P24-09
Event Center and Parking Lot

Property Owner: Legacy Hotel of Medina LLC
 Applicant: Ian Jones
 Location: 253/257 South Court Street and 226 South Elmwood Avenue
 Zoning: C-2 (Central Business)
 Request: Conditional Zoning Certificate and Site Plan approval for the construction of an event center and parking lot

COMMUNITY DEVELOPMENT DEPARTMENT STAFF RECOMMENDATION

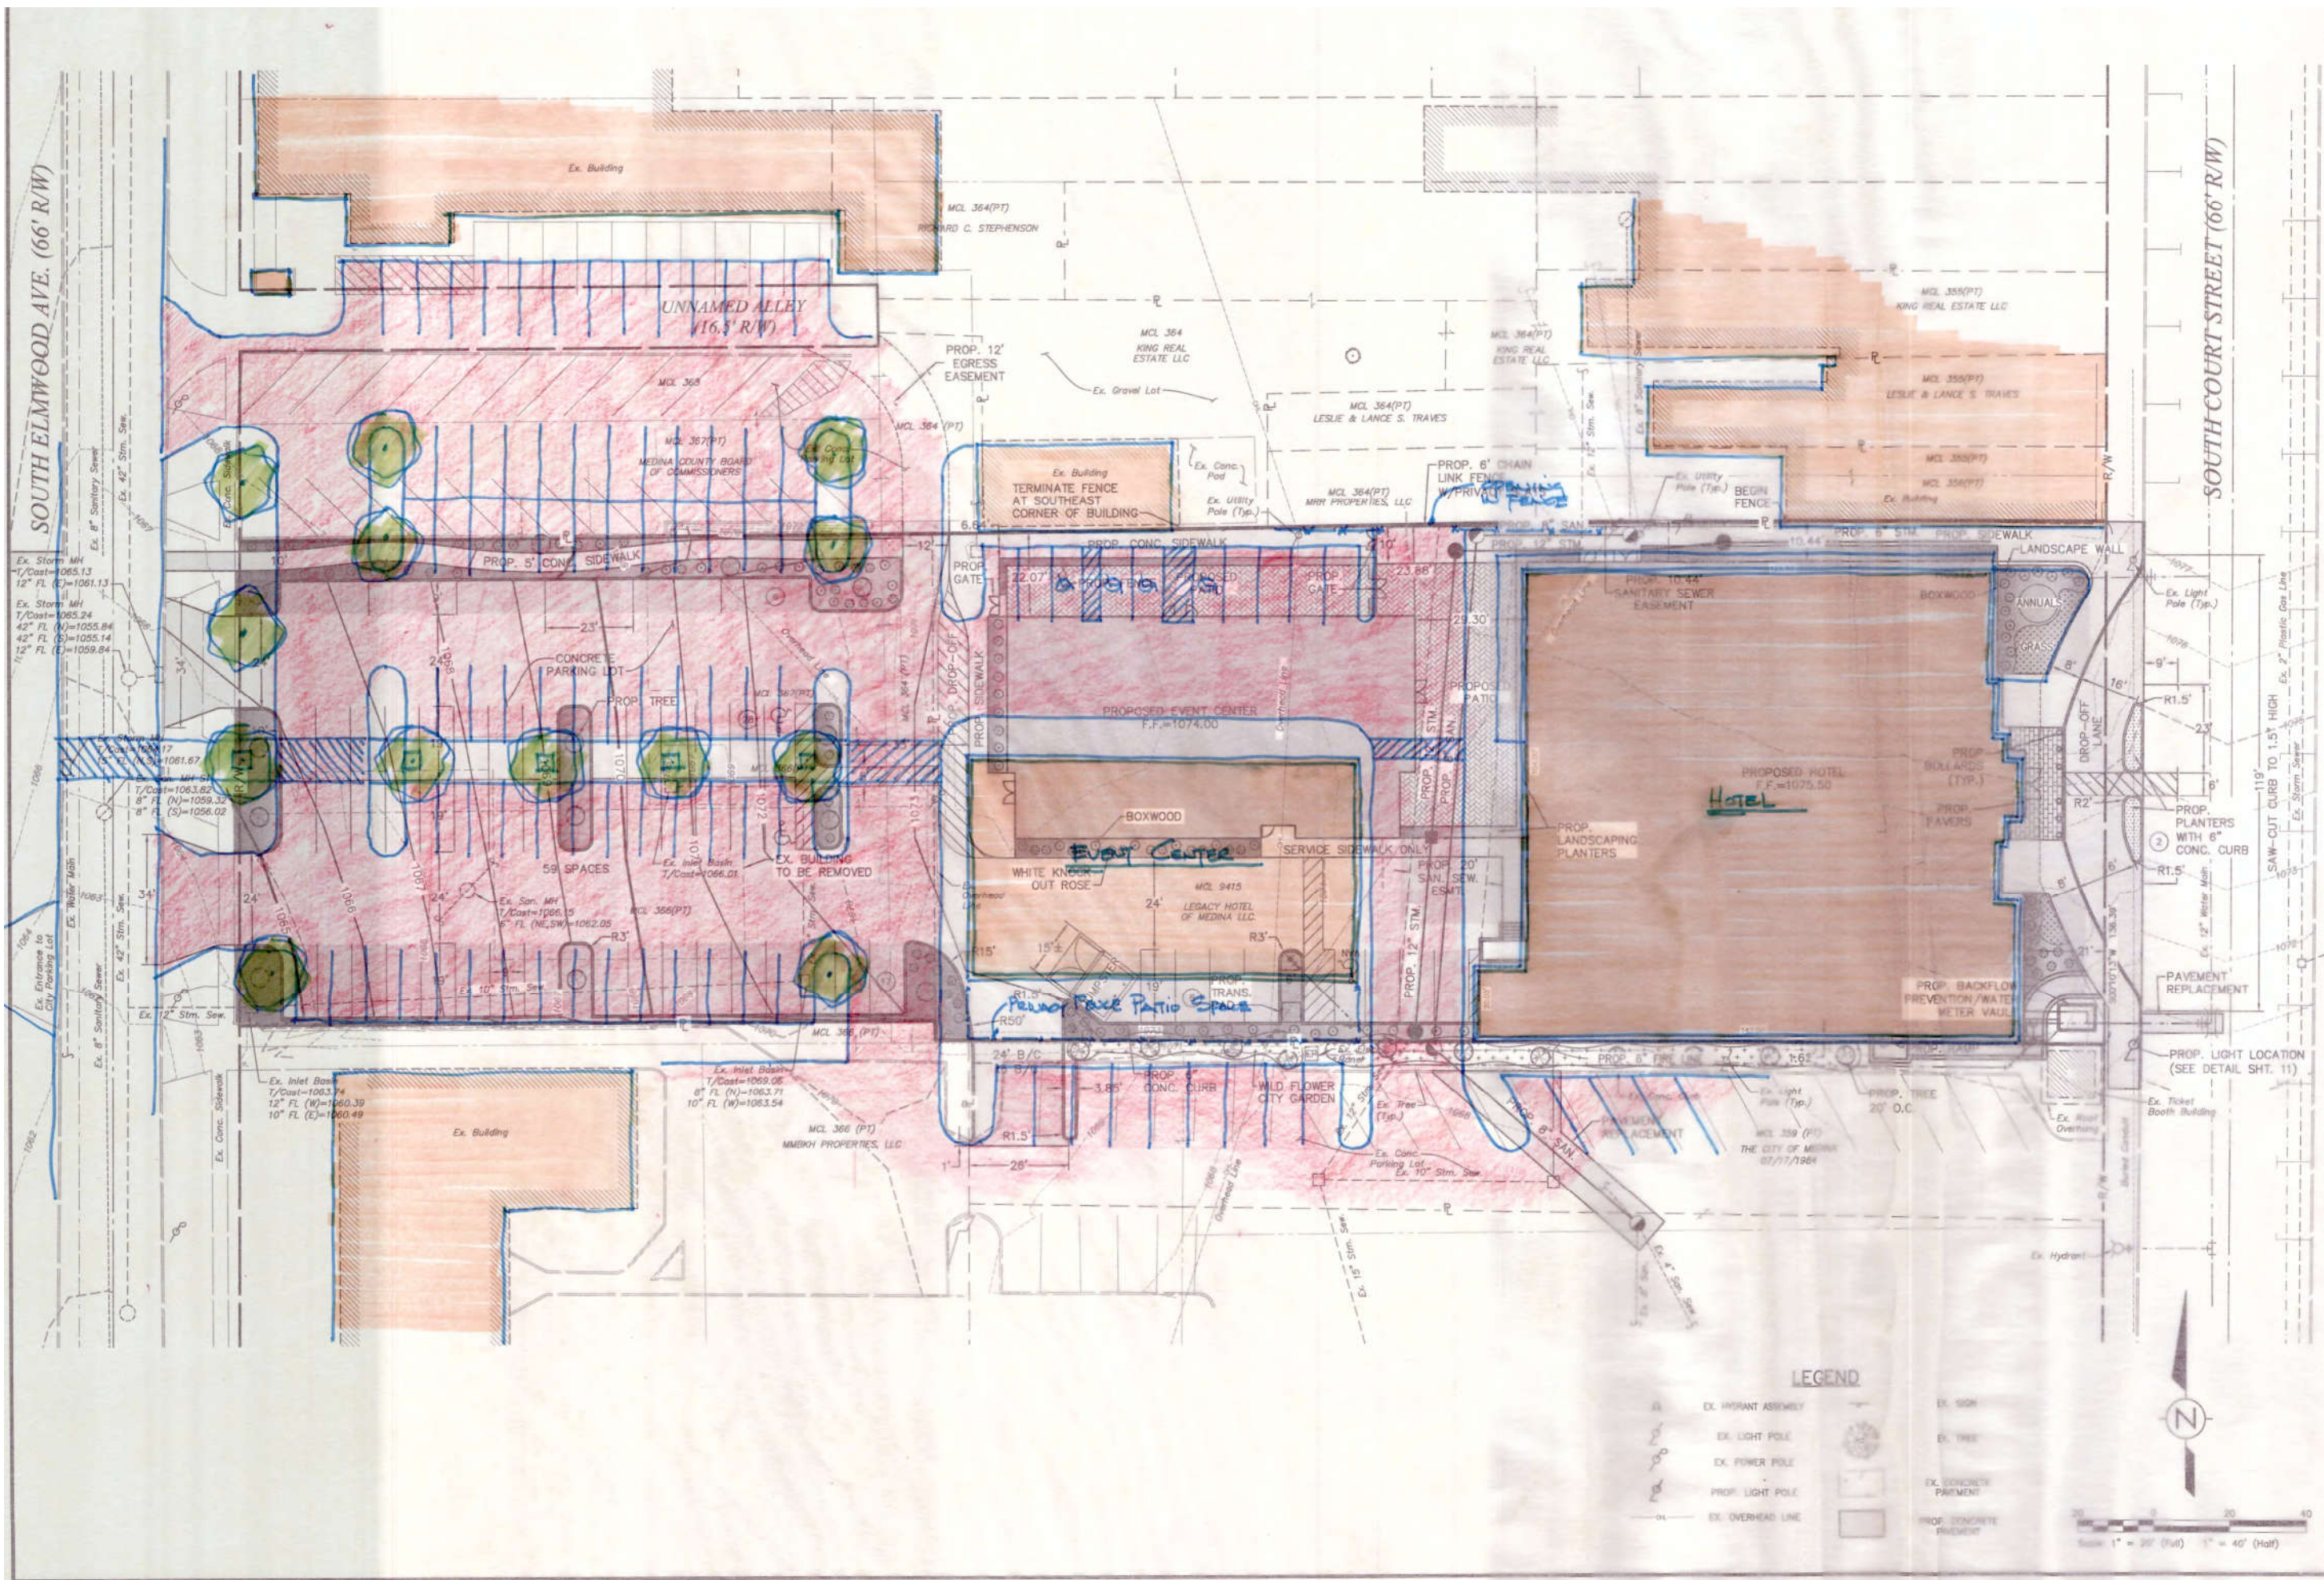
Rose Company has requested I review the above referenced project, the Event Center for the Legacy Hotel, relative to the impact the project may have on their property at 241 South Court Street and provide you with my thoughts. One of their main concerns is maintaining access to the back of 241 South Court from the south, which is across the hotel property. As a resident of the community, I expanded my assessment to also assess how the project as a whole might integrate into the community and as a result, developed the alternative site plan for the project which I have attached.

be directly impacted by a unified parking layout is reduced and the opportunity to really enhance the parking for the community substantially improves. The removal of the NAPA store makes the area available for developing a unified parking plan. In the plan we are proposing, the area for parking redevelopment expands north to include both the county parking lot and the parking area behind Park Exchange. Both of these lots have parking that is difficult to use and is not compliant with city standards.

Utilizing all of this space and reconfiguring the layout, we are able to create a single large lot that provides parking that is both compliant with the city standards and corrects some hazardous conditions associated with the existing layout. As an example, the drive directly behind Park Exchange, is wide enough for one way traffic, but sees traffic in both direction as well as services the parking along Park Exchange. In addition, by moving the event center to the south, we are able to revise the layout of the drives and improve general circulation from the Feckley parking lot on the south through the event center and into this new parking lot. This plan also allows access to the west side of 241 South Court, a prime concern of Rose Company, and access which has existed to service 241 South Court for as long as I can remember.

By shifting the event center south, it also improves the walkway from South Court through the block and to the parking on the west, enhancing the opportunity to bring more people into the district. With the location for the Event Center to the south, the walkway is more open along its length, only enclosed between two buildings for a short length. We have also moved the walkway further south where it goes through the new parking area. In this proposed location, the walkway more closely aligns with the city parking lot on the west side of Elmwood. The addition of a crosswalk here, similar to what is found on the square, will enhance the connection between this underutilized parking area and the square.

Attachment 1: hand drawn Rose Plan for 257 S Court Street

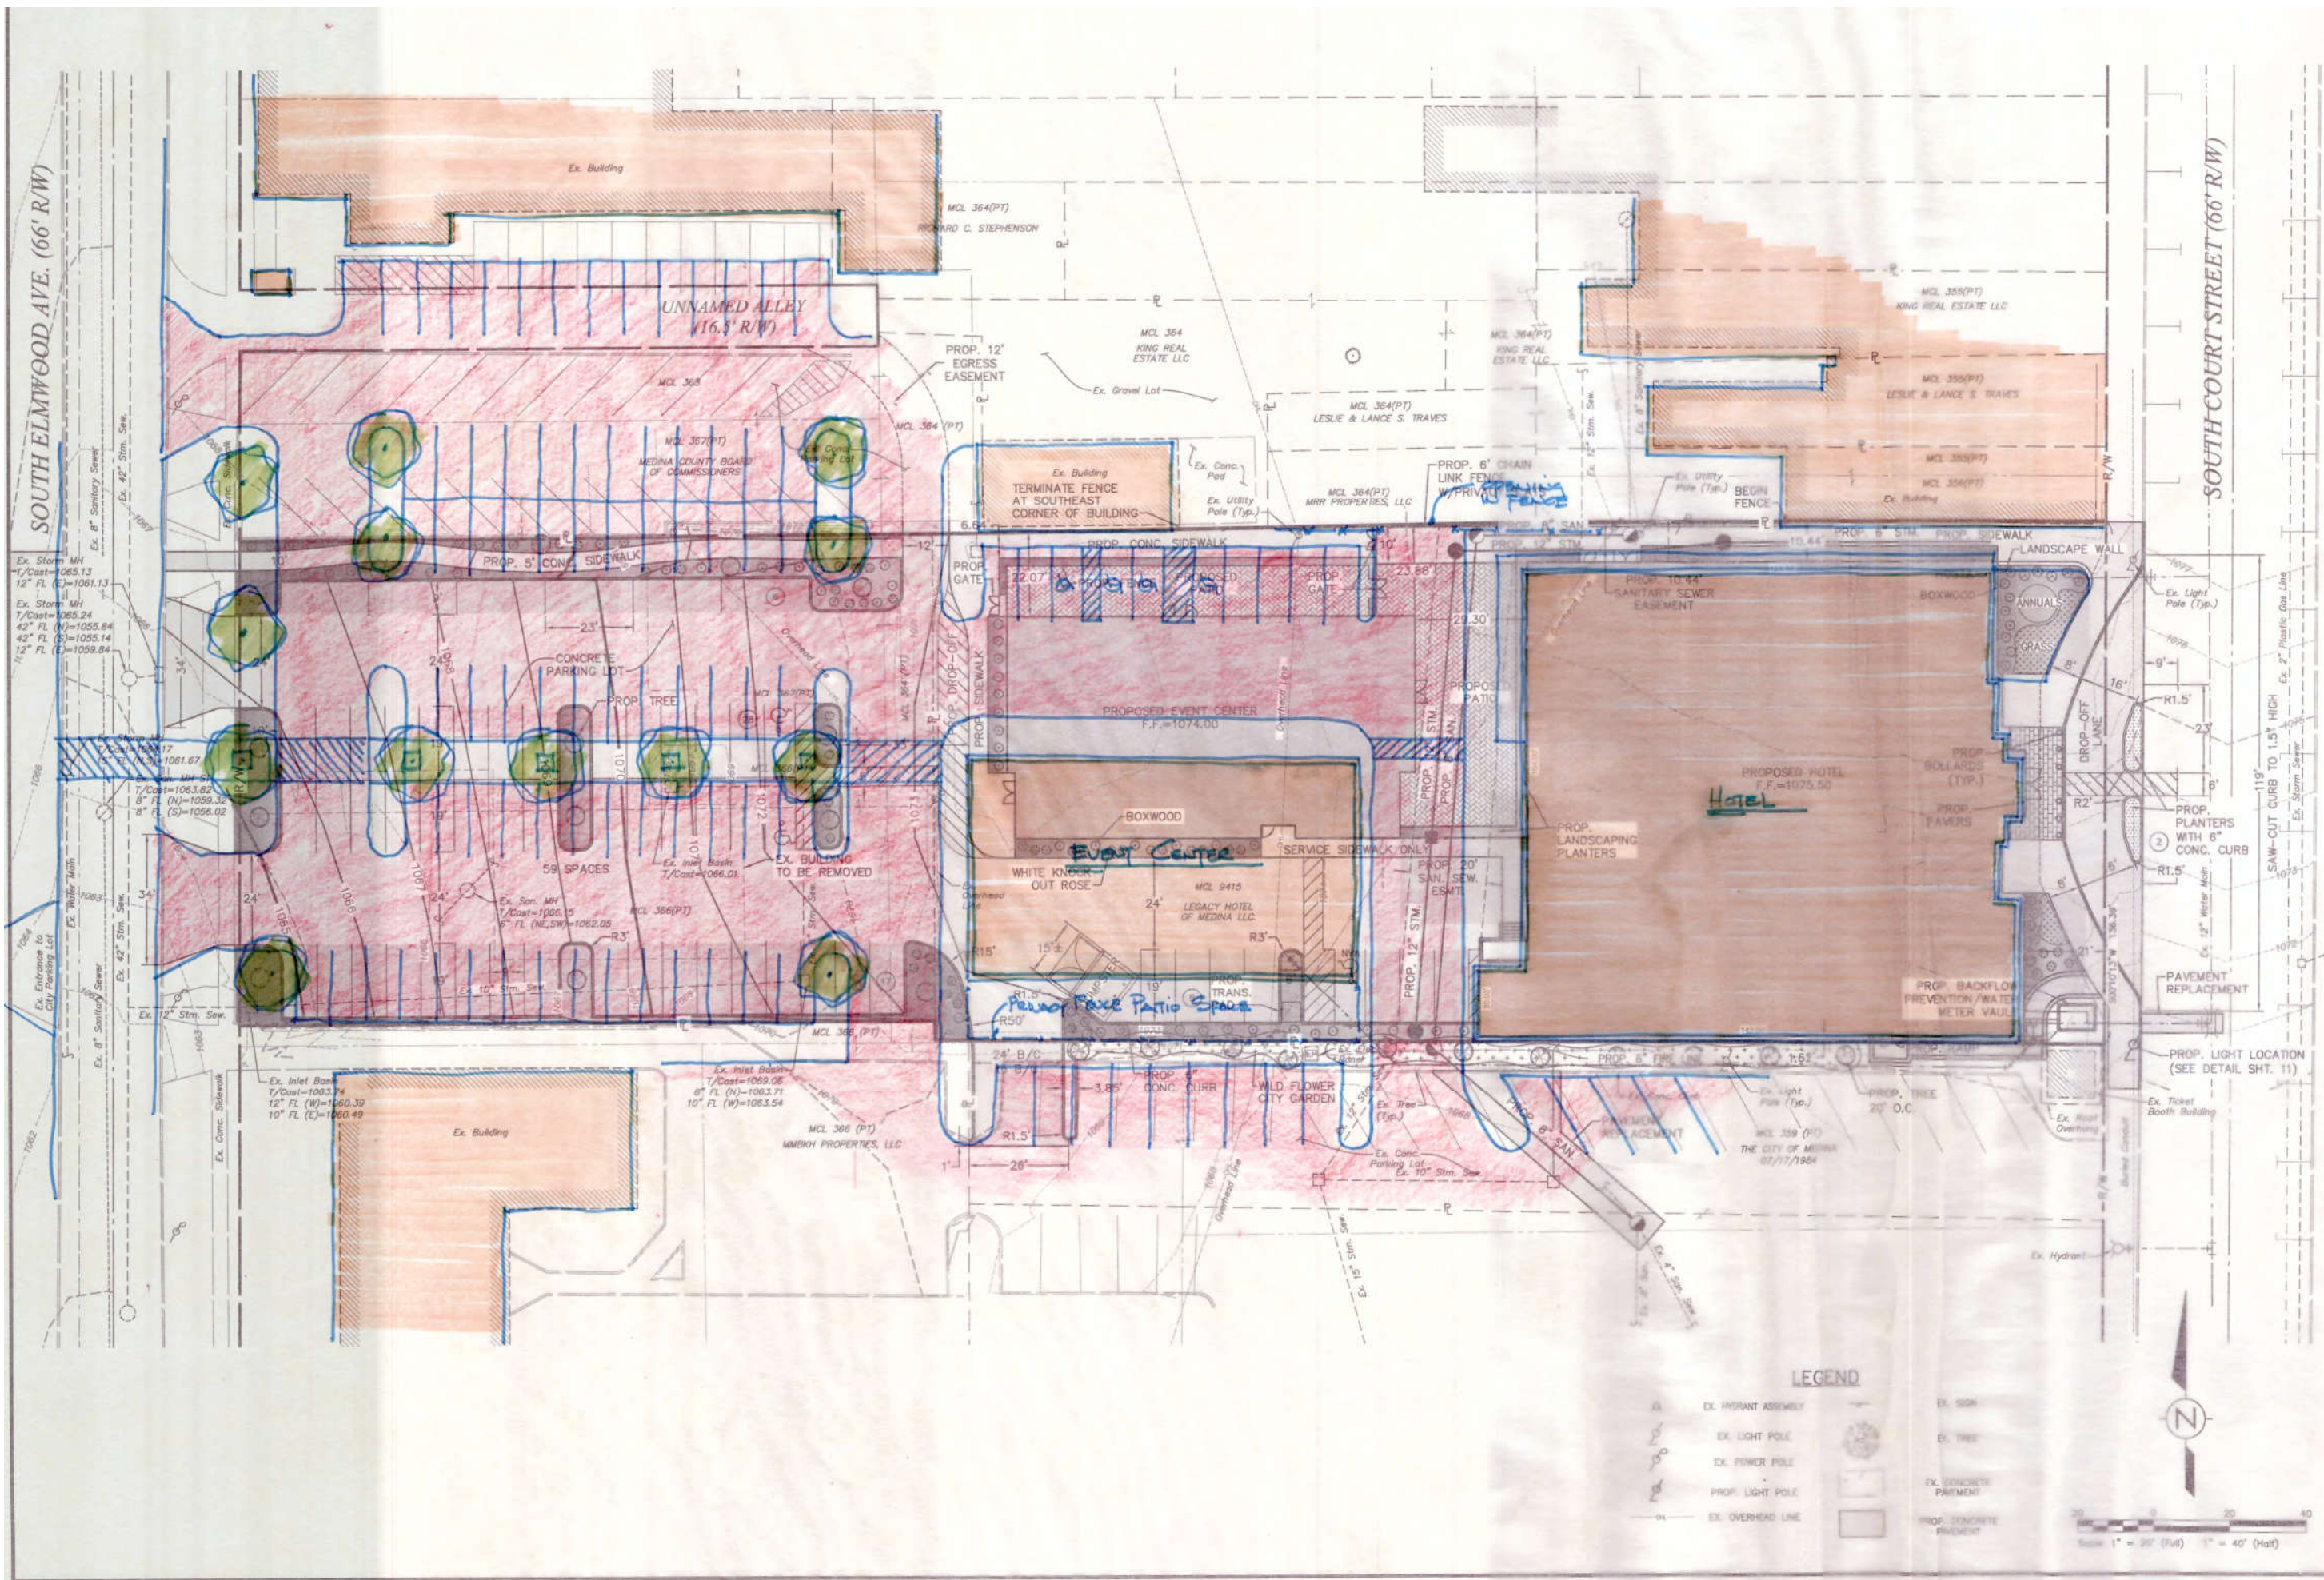
More importantly, I do not support the Rose Plan as this version would result in the taking of my property and other neighboring properties for a required Private Road and result in significant adverse impacts on the use and condition of my property and neighboring properties. Additional information and comments on the Rose Plan is also provided below.

I reviewing the informational Rose Plan, I believe this plan is addressing comments the Rose Company and north adjacent property owner submitted at the BZA meeting held Tuesday March 12, 2024. These comments indicated that the Rose Company (and owner of the northeast adjacent property) claim to have a right of access for vehicles from their property to travel across the Proposed Hotel property to South Court Street.

However, I understand that a right of access is not contained in a legally described instrument. In fact, the current and historical described access has been reported to me (and I expect others in Medina) as simply being the result of the current north adjacent property owner removing a previously existing fence section. Whether or not this was done legally is still to be determined. More importantly, I believe the City of Medina and Planning Commission are not legally authorized to grant any site plan change that would significantly adversely impact numerous nearby businesses all for the sole benefit of a single property owner (that is Not the Applicant) that also has undocumented and unconfirmed claims of rights to access across the Proposed Hotel property.

As previously submitted to the Planning Commission and the City of Medina during the initial Proposed Hotel site plan approval (Case P-22-19) any northeast open (i.e., ungated) access road from the Proposed Hotel north through the adjacent properties will clearly meet the definition of a Private Road as it will also allow access for random guests and others from the Hotel to travel across 4 nearby properties. As such, under City of Medina Code the private Road will be required to meet Public Road construction requirements. **The construction of such a designed road will result in a Taking of Property and Use from myself and all the other affected properties.**

Furthermore, the City of Medina is also obligated to advise the PCB and BZA that they are required by Ordinance and Ohio law to consider the adverse impacts of the Private Road in the Rose Plan on my property and the other property owners in the evaluation of the most recent revised site plan and any requested Variances that are directly linked to significant changes to the site plan. Again, the Rose Plan is based on undocumented rights of the Rose Company and north adjacent property owner. To advise otherwise would be unreasonable and inappropriate.

Therefore, prior to any consideration of the Rose Plan I believe the City of Medina must first detail the engineering and construction aspects that a Private Road that would travel across our properties. Only then could the significant adverse impacts of the Private Road on my property and the neighboring properties be identified and evaluated by the Planning Commission and BZA.
